[Docket No. 2000-NM-94-AD; Amendment
39-11712; AD 2000-09-04]

Airworthiness Directives; Boeing Model 767 Series Airplanes Equipped with General Electric Model CF6-80C2 Series Engines

ACTION: Final rule; request for
comments.

Electro-Mechanical Brake and CDU Cone Brake Torque Check
Figure 1

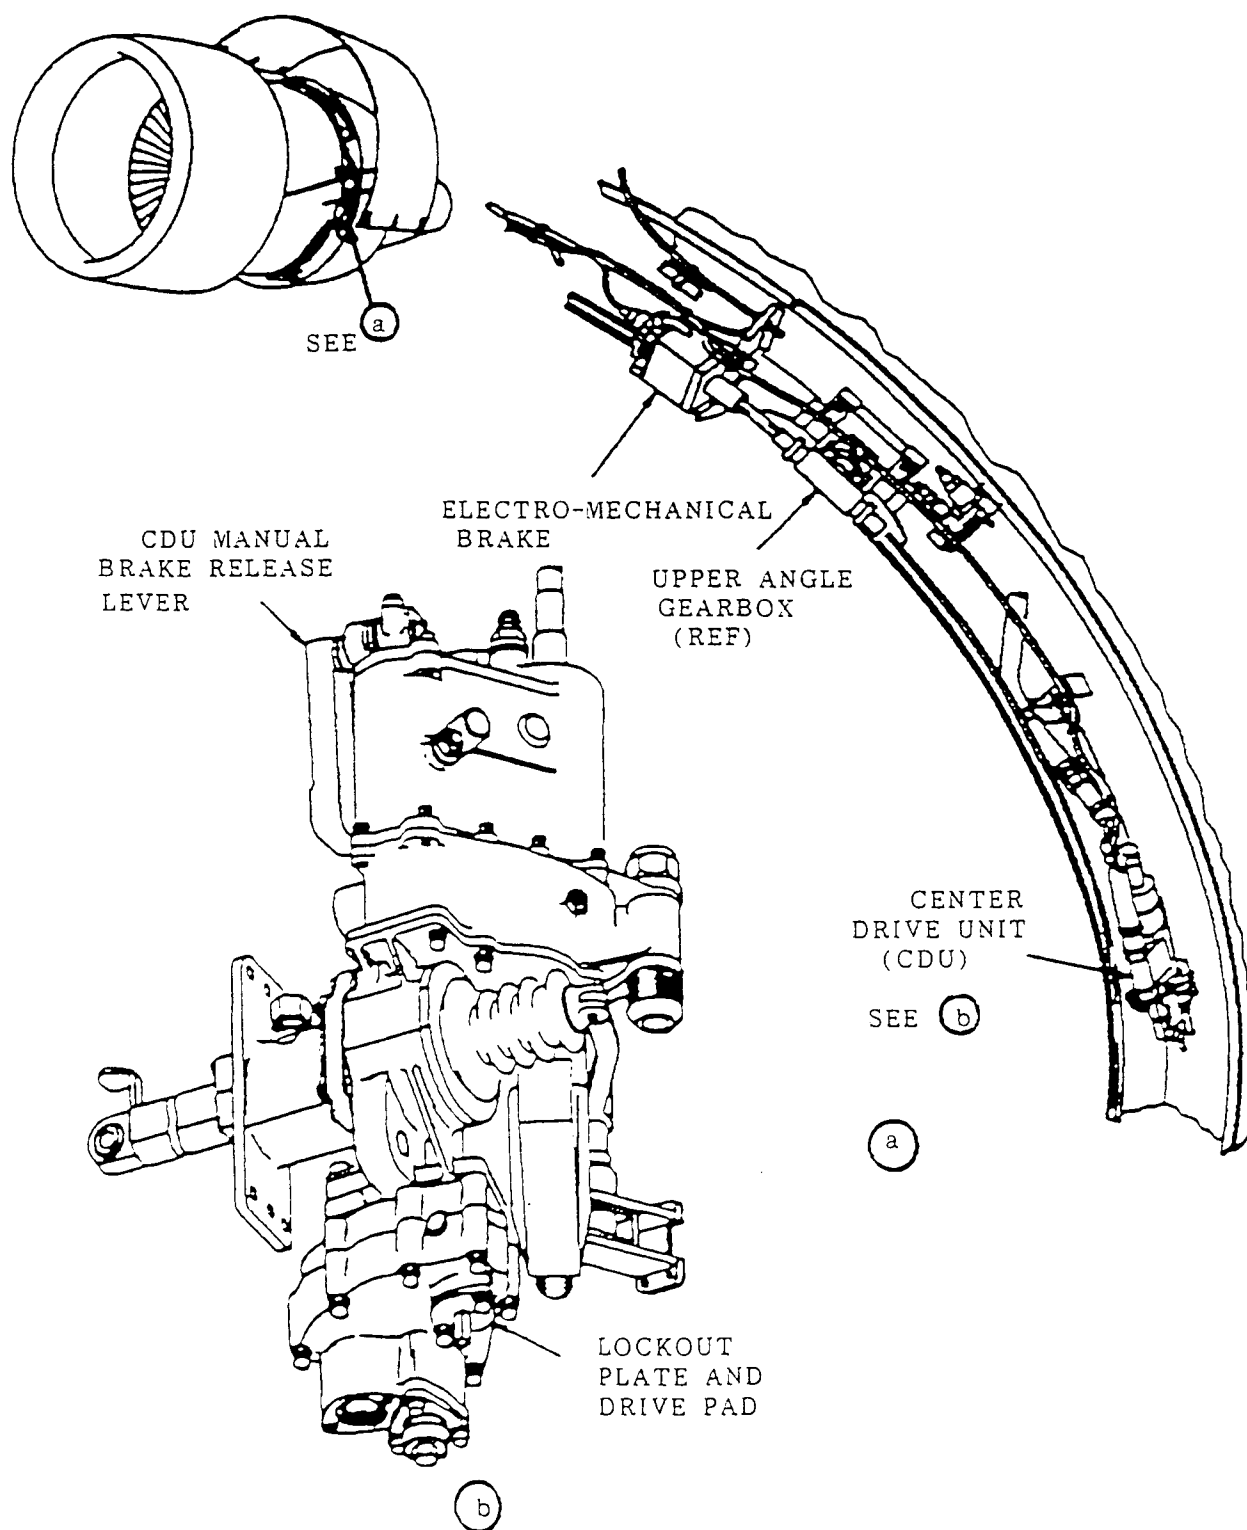
2. Electro-Mechanical Brake and CDU Cone Brake Torque Check (Fig. 1)

(a) Manually extend the thrust reverser six inches and measure the running torque.

(1) Make sure the torque is less than 10 pound-inches.

(e) Apply 90 pound-inches of torque to the system.

(1) The electro-mechanical brake system is working correctly if the torque is reached before you turn the wrench 450 degrees (1 1/4 turns).

(2) If the flexshaft turns more than 450 degrees before you reach the specified torque, you must replace the long flexshaft between the CDU and the upper angle gearbox.

(3) If you do not get 90 pound-inches of torque, you must replace the electro-mechanical brake.

(1) If the wrench does not return to within 30 degrees of initial starting point, you must

replace the long flexshaft between the CDU and upper angle gearbox.

CAUTION: DO NOT USE MORE THAN 100 POUND-INCHES OF TORQUE WHEN YOU DO THIS CHECK. EXCESSIVE TORQUE WILL DAMAGE THE CDU.

(6) Turn the torque wrench to try to manually extend the translating cowl until you get at least 15-pound inches.

(a) If the torque is less than 15-pound-inches, you must replace the CDU.
